Docket Number 50-346

Subject: Request for Relief From Certain ASME Code Requirements for
Inservice Inspection for the Davis-Besse Nuclear Power
Station

RELIEF REQUEST RR-A10

RELIEF REQUEST
RR-A11

REACTOR COOLANT BRANCH CONNECTION WELDS

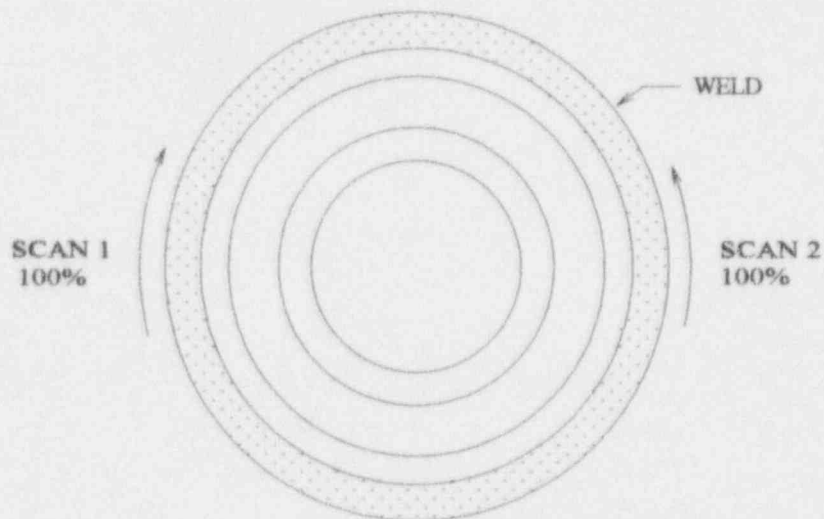
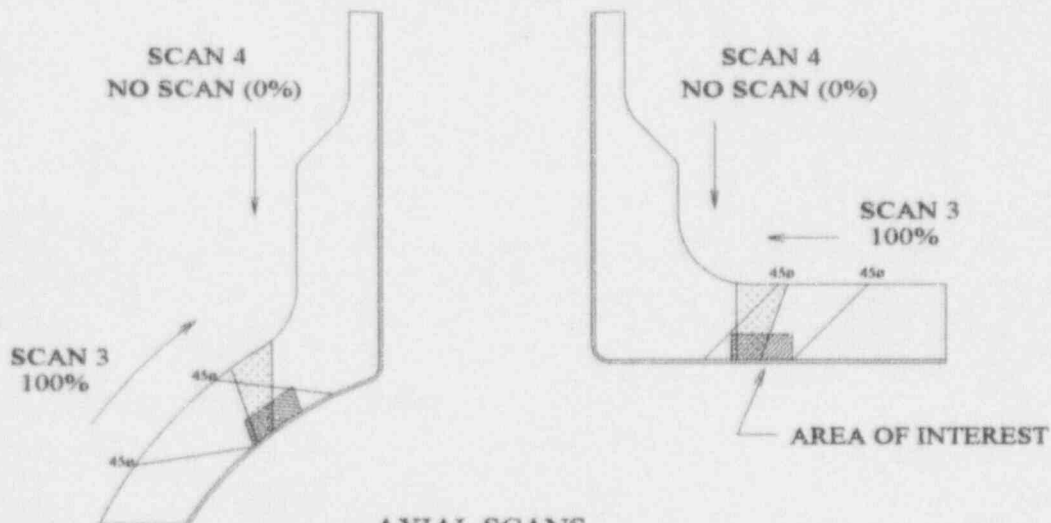
The Reactor Coolant Piping is clad which limits the examination path to a one-half vee sound path.

Each branch connection weld can be completely (100 percent) examined circumferentially in both directions. It can also be examined completely (100 percent) in the axial direction from the pipe surface. However, no reliable scan can be performed from the nozzle side due to the nozzle radius interfering with the examination scan. The Reactor Coolant Piping cladding also limits the ability to "bounce" the ultrasonic beam from the pipe side of the weld to obtain coverage in the fourth beam direction. Therefore, only 3 of the 4 required beam directions can be obtained. This results in 75 percent of the examination coverage. The attached sketch provides an illustration of the typical nozzle configuration and examination coverage.

SCAN 1 - 100% COVERAGE
SCAN 2 - 100% COVERAGE
SCAN 3 - 100% COVERAGE
SCAN 4 - 0% COVERAGE
AVERAGE OF THE FOUR SCANS = EXAM 75% COMPLETE

CIRCUMFERENTIAL SCANS
100% COVERAGE

AXIAL SCANS
50% COVERAGE

Each weld will be examined in the circumferential direction in accordance with ASME Code requirements. Each weld will be examined in the axial direction from the pipe surface only. The surface examination will be performed as required by the ASME Code.

PRESSURIZER SPRAY NOZZLE

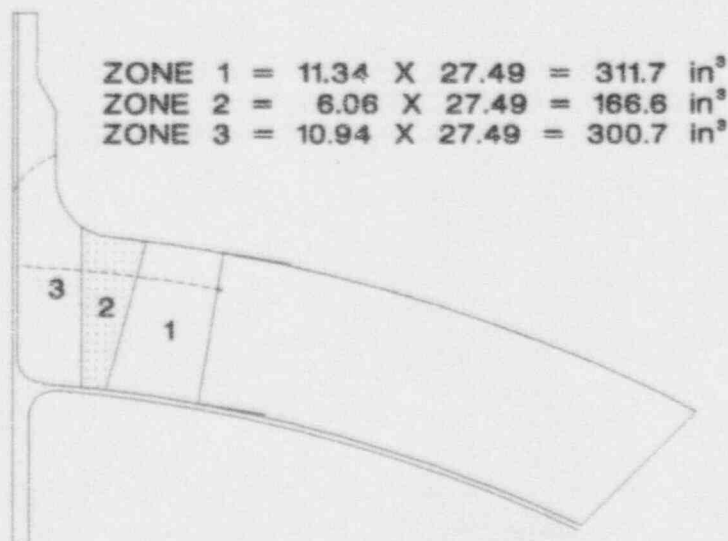
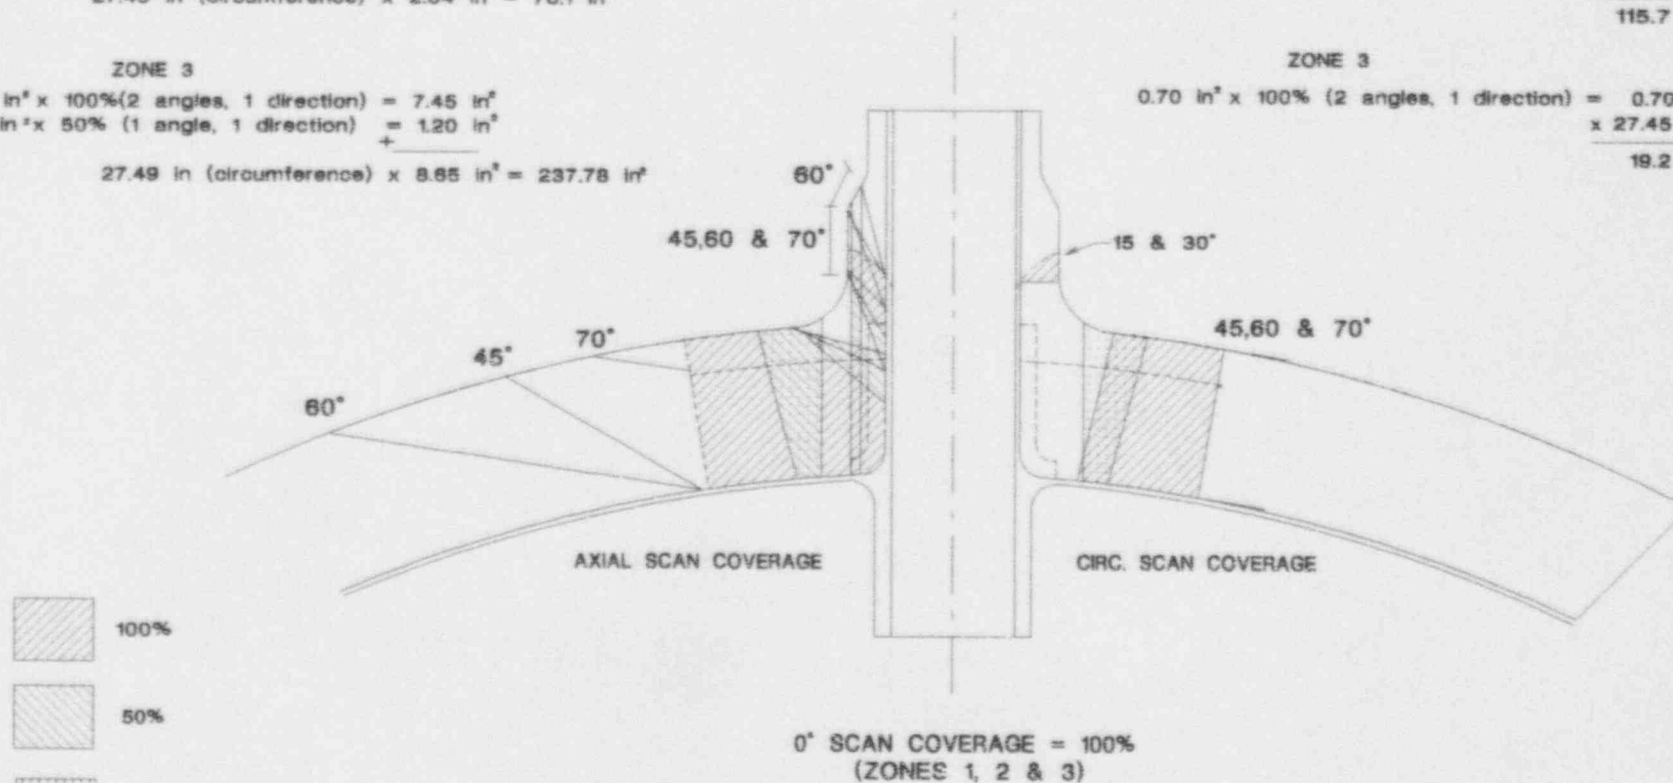
The volumetric examination of the identified welds and inside radii is limited by the nozzle configurations and the inability to "bounce" the ultrasonic beam from the vessel's inside clad surface. This reduces the examination coverage more than 10 percent.

Component	Examination Coverage
Pressurizer Spray Nozzle to Upper Pressurizer Head Weld	72%
Pressurizer Relief Nozzle to Upper Pressurizer Head Weld	60%
Pressurizer Surge Line Nozzle to Lower Pressurizer Head Weld	69%
Steam Generator Outlet Nozzle to Lower Head Weld	75%
Steam Generator Inlet Nozzle to Upper Head Weld	72%
Pressurizer Spray Nozzle Inside Radius Section	45%
Pressurizer Relief Nozzle Inside Radius Section	51%
Pressurizer Surge Line Nozzle Inside Radius Section	50%
Steam Generator Outlet Nozzle Inside Radius Section	46%
Steam Generator Inlet Nozzle Inside Radius Section	52%

ZONE	TOTAL VOLUME (in. ³)	COVERAGE (in ³)			TOTAL % COMPLETE
		AXIAL	CIRC.	0°	
1	311.7	311.7	311.7	311.7	100%
		X .40	X .40	X .20	
		124.7	124.7	62.34	
2	166.6	78.1	115.7	166.6	83.2%
		X .44	X .44	X .12	
		34.4	50.9	19.99	
3	300.7	237.78	19.2	300.7	54.2%
		X .40	X .40	X .20	
		95.11	7.7	60.14	
					72%

Each weld will be examined to the maximum extent practical within the principals of ALARA.

PZR. SPRAY NOZ. - Inside Radius Exam.

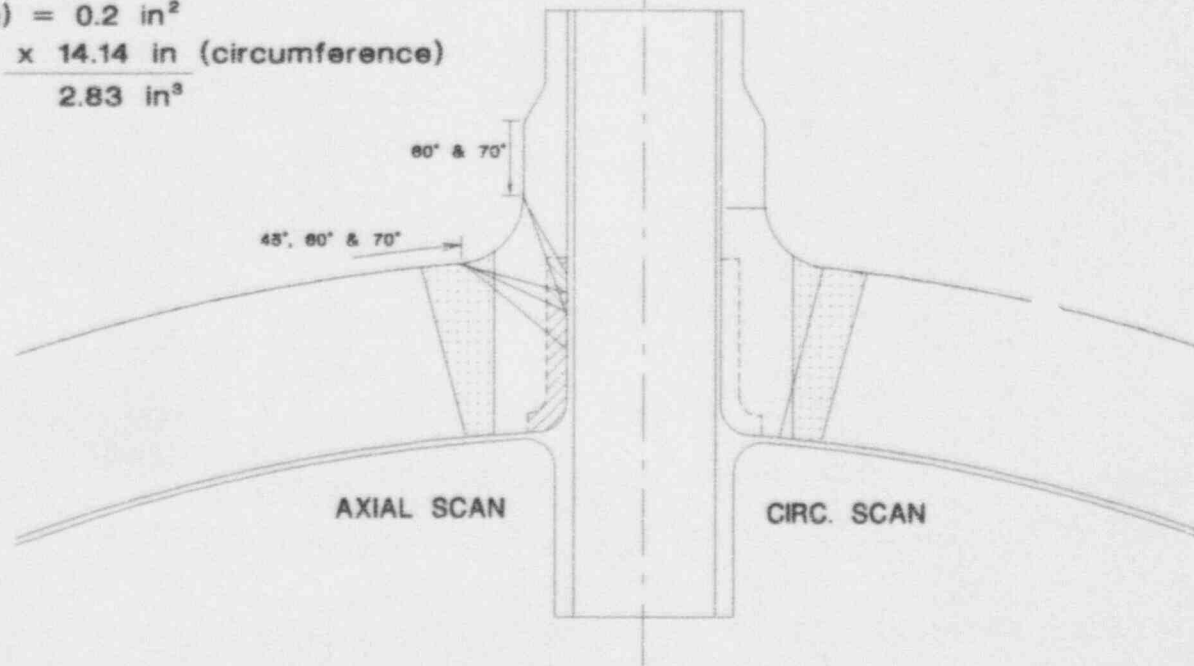
AREA 4 TOTAL AREA = 2.45
 AREA 4 CIRCUMFERENCE = 14.14

AREA	TOTAL VOLUME (in. ³)	COVERAGE		TOTAL % COMPLETE
		AXIAL	CIRC.	
4	34.64	31.1	0.0	45%
		X .50	X .50	
		15.55	0.0

CIRCUMFERENTIAL DIRECTION COVERAGE
 0.0 in³
